Capstone Flooring Renovation Project Columbia, South Carolina University Project Number H27-Z384

April 4, 2019

#### ADDENDUM No. 4

## SEVENTEENTH FLOOR - DEMOLITION PLAN

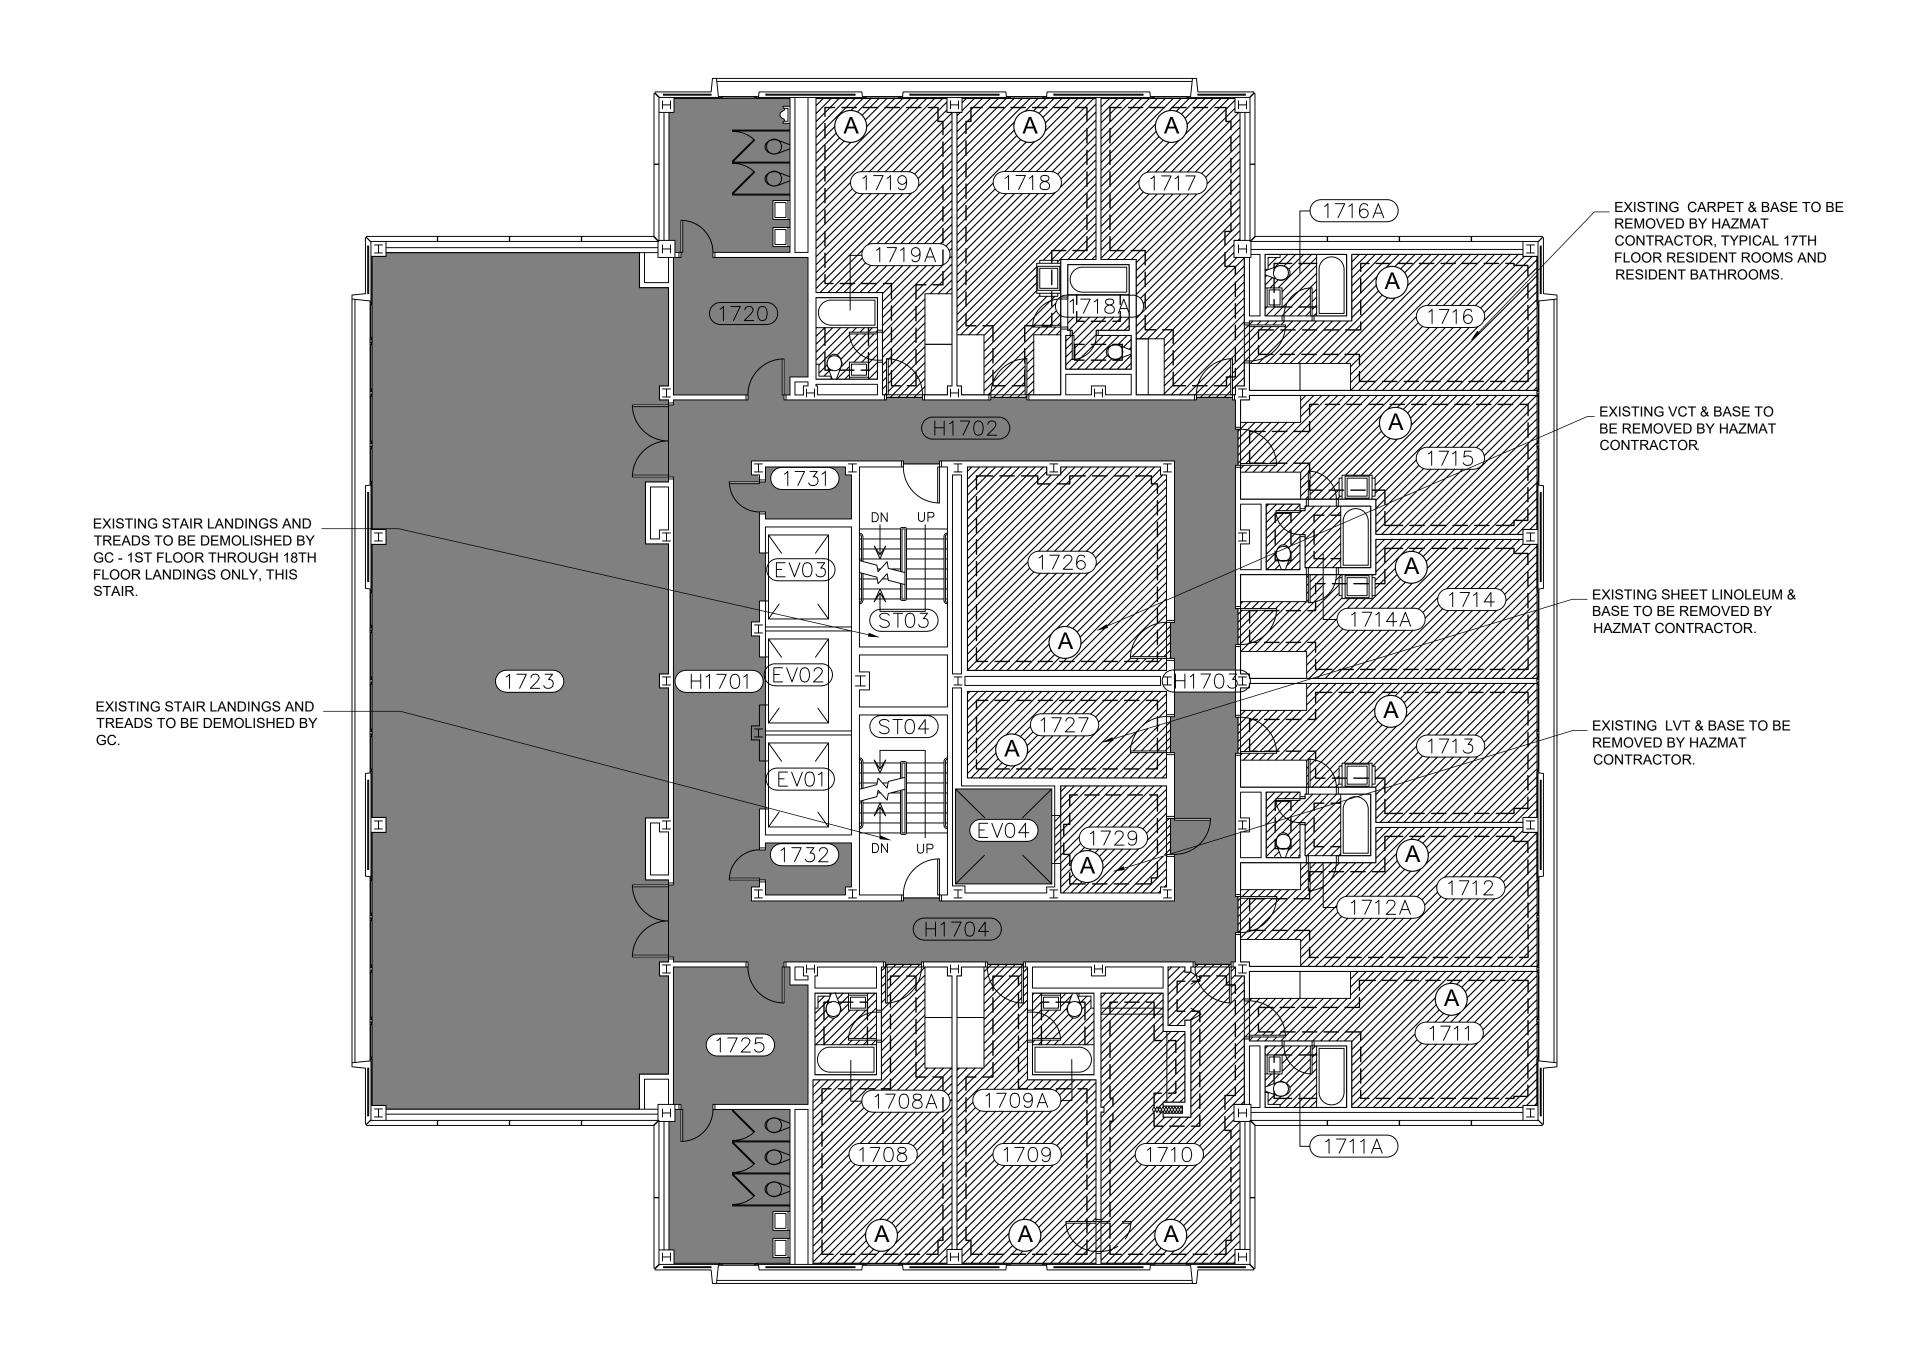
- 1. Reference Sheet ID0.4, dated 02-27-2019, revised 04-02-19: DELETE Sheet and ADD in its place Sheet ID0.4, dated 02-27-2019, revised 04-04-19, attached.
  - a. Clarifications to General Contractor Scope of Work
- 2. Reference Sheet ID2.4, dated 02-27-2019, revised 04-02-19: DELETE Sheet and ADD in its place Sheet ID2.4, dated 02-27-2019, revised 04-04-19, attached.
  - a. Clarifications to General Contractor Scope of Work

- 1. Are we required to remove all toilets or are we to install flooring around existing toilets?
  - a. See MODIFICATIONS TO DRAWINGS, this Addendum.
- 2. Roppe #93 Textured Tread (ST-1) does not come with an attached riser. How will risers be addressed?
  - a. No resilient riser product is anticipated nor specified to be used at any of the Stairs located within the project scope. Risers were painted last summer and are anticipated to remain exposed, painted risers. Should General Contractor damage surface of exposed riser/stair during the tread/landing install; General Contractor shall be responsible for the repair of painted surface to 'like-new' condition, unless previous photographic documentation suggests otherwise.

\*\*\*\*\*IMPORTANT NOTE RELATED TO THIS FLOOR ONLY: GC SHALL REMOVE EXISTING TOILETS FROM RESIDENT ROOM PRIVATE BATHROOMS ON THE 17TH FLOOR ONLY. THIS SHALL OCCUR PRIOR TO HAZMAT REMOVING EXISTING VCT FLOORING. SCHEDULING AND SEQUENCING OF EVENTS TO BE DISCUSSED AT THE PRE-CONSTRUCTION MEETING WITH ALL RELATED PARTIES. GC SHALL VERIFY ALL TOILETS ARE IN PROPER WORKING CONDITION PRIOR TO DISCONNECTING EXISTING TOILETS. GC SHALL STORE TOILETS ONSITE; PREFERABLY WITHIN THE RESIDENT ROOM FROM WHICH THEY WERE DISCONNECTED; FOR RE-INSTALLATION IN THE SAME RESIDENT BATHROOM. NOTIFY ARCHITECT OF ANY ISSUES AFTER FIELD VERIFICATION OF PROPER WORKING CONDITIONS OF EXISTING TOILETS. GC SHALL BE RESPONSIBLE FOR REINSTALLING EXISTING TOILETS IN PROPER WORKING CONDITIONS AFTER THE INSTALLATION OF NEW FLOORING.
